SUBJECT: IN THE MATTER OF 238 NUCLEAR ISLAND
GENERAL ELECTRIC STANDARD SAFETY ANALYSIS REPORT (GESSAR II);
DOCKET NO. STN 50-447

Attached please find draft responses to the Commission's August 25, 1982 request for additional information on GESSAR II. These responses, provided in Attachment Nos. 1 through 8, reflect the NRC/GE information exchange meetings held in Bethesda from October 7, 1982 through October 26, 1982.

ATTACHMENT NO. 1

DRAFT RESPONSES TO
STRUCTURAL ENGINEERING BRANCH
QUESTIONS

Figure 9.5-16. Division 1 and 2 Diesel-Generator Lube Oil System P&I Diagram

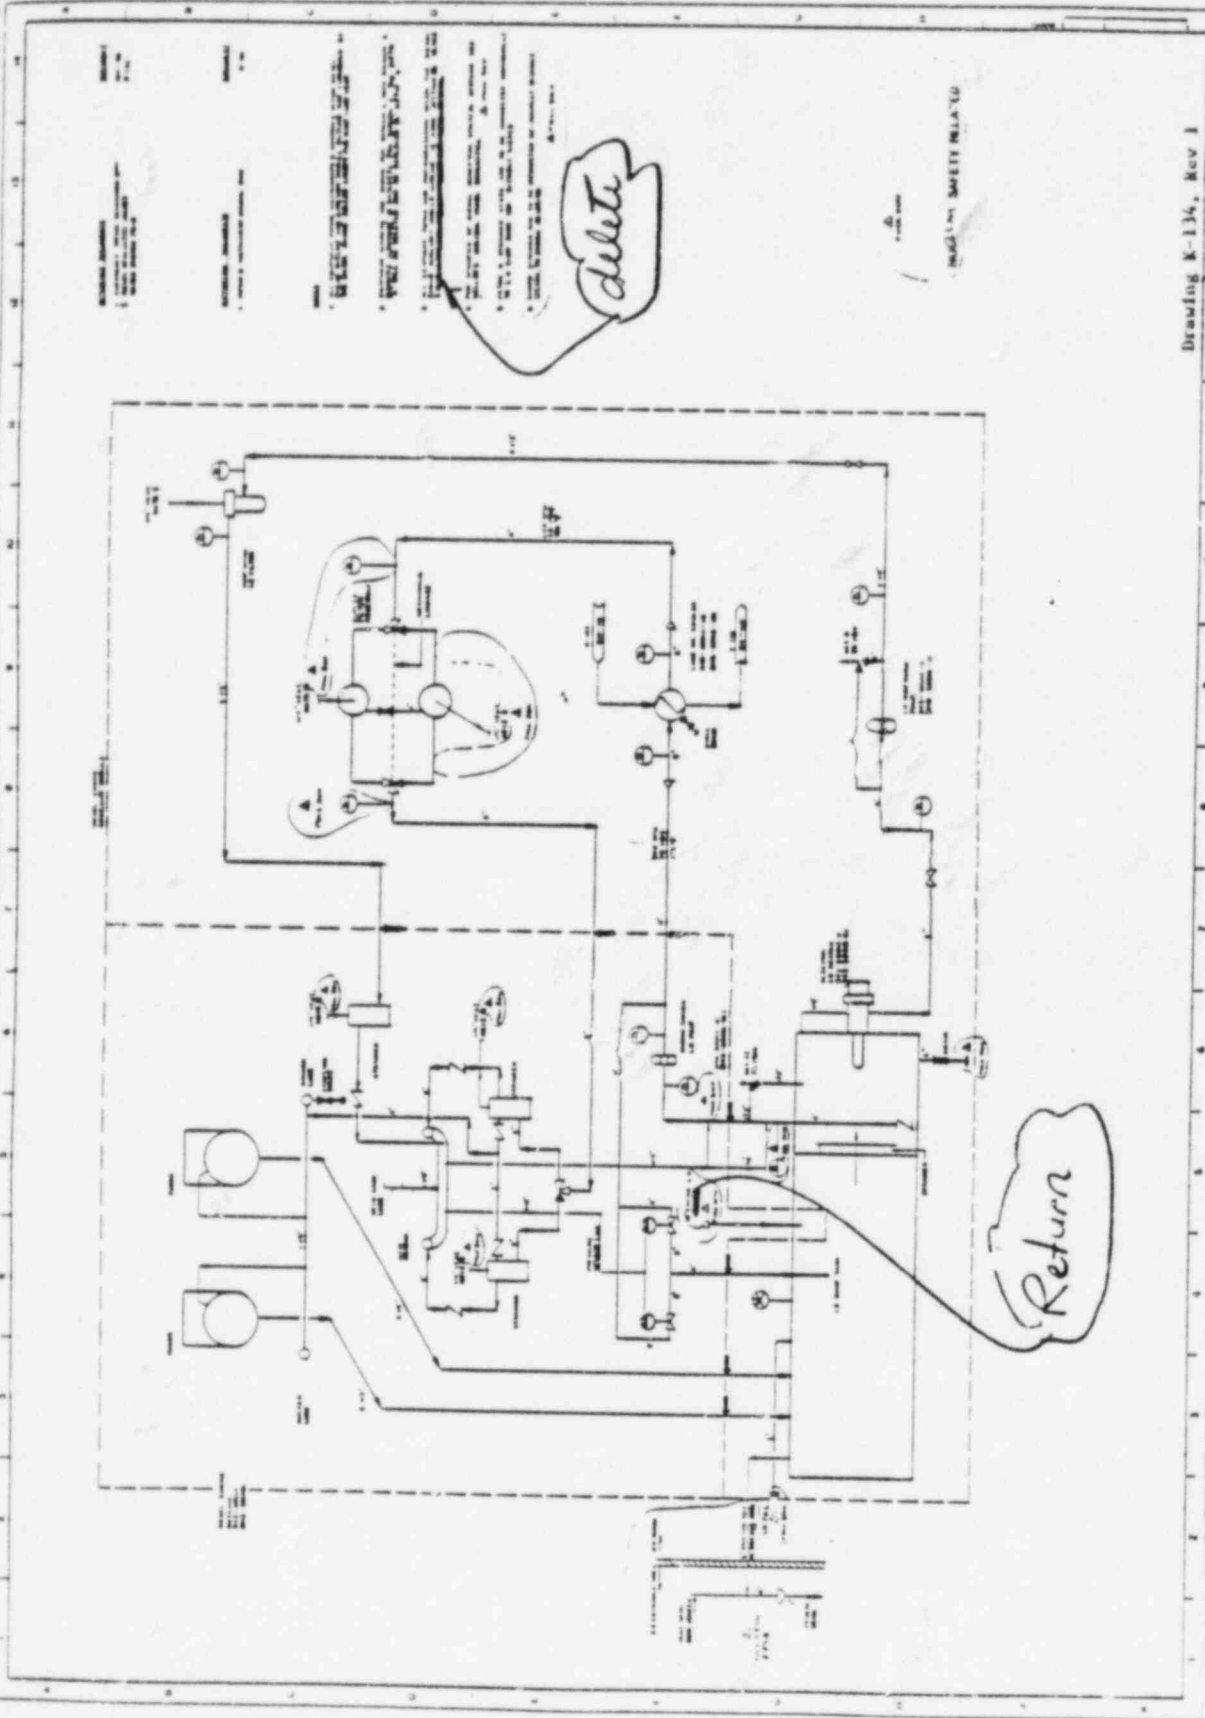
On Figure 9.5-16, you show a 12 inch "engine L.O. drain," and a 2 inch "drain." Explain the function of each of these drains.

The function of 12 inch engine lube oil drain as shown on figure 9.5-16 is to return lube oil from the diesel-engine to the lube oil sump tank. The function of the 2 inch drain is to empty the lube oil sump tank, as necessary, to replenish the dirty lube oil with clean lube oil, and during maintenance or plant shutdown where repairs are needed to be done on the lube oil sump tank and components located inside the sump tank, Figure 9.5-16 will be revised to change 12 inch engine lube oil "drain" to "return", as shown on the attached marked up Figure 9.5-16.

Figure 14.1-1 Power-Flow Operating Map
(Revised)

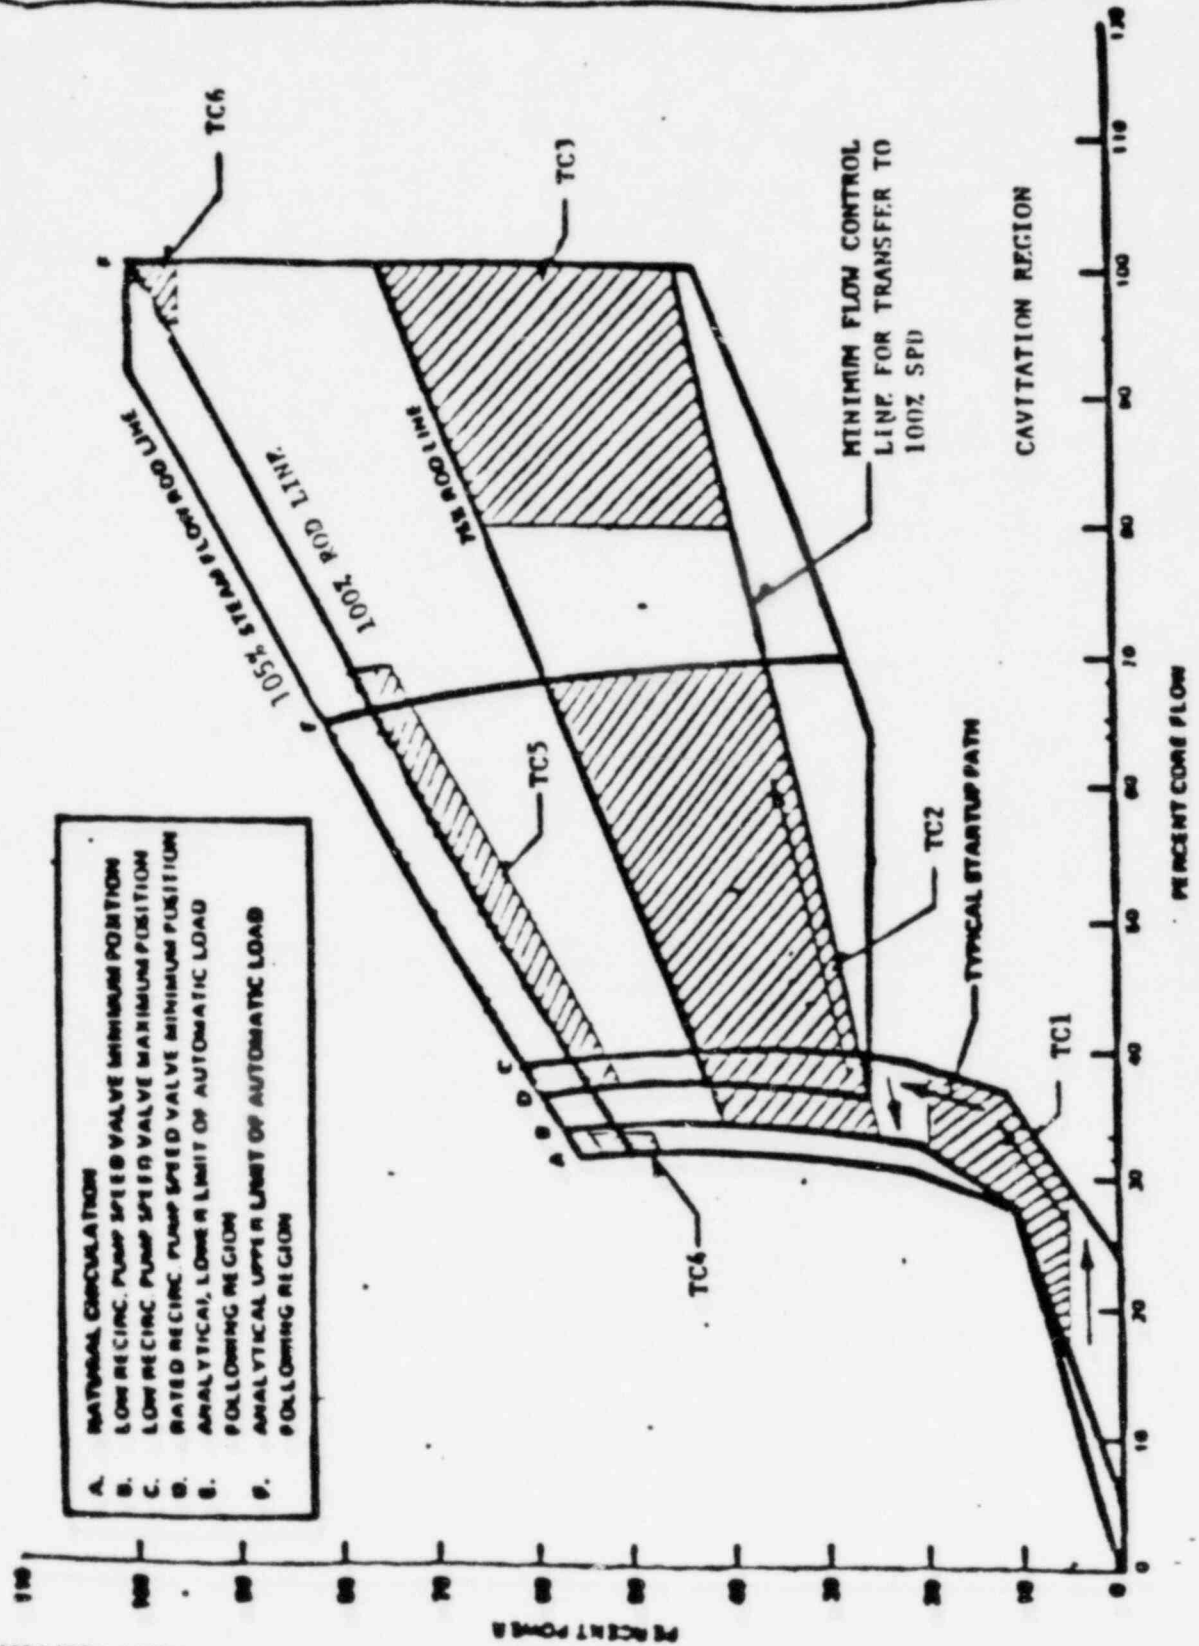
640.01
(14.1) Modify Table 14.1-3 and Figure 14.1-1 of your FSAR to either delete the reference to Test Condition 7 or to state why it has been included since no tests are indicated as being conducted at these conditions. Additionally, operation in excess of your rated thermal power is not permitted.

Figure 14.1-1 was revised accordingly. Table 14.1-3 will be revised in January 1983. (The revised table will reflect the recently completed Clinton STS -- provided in Attachment No. 8)
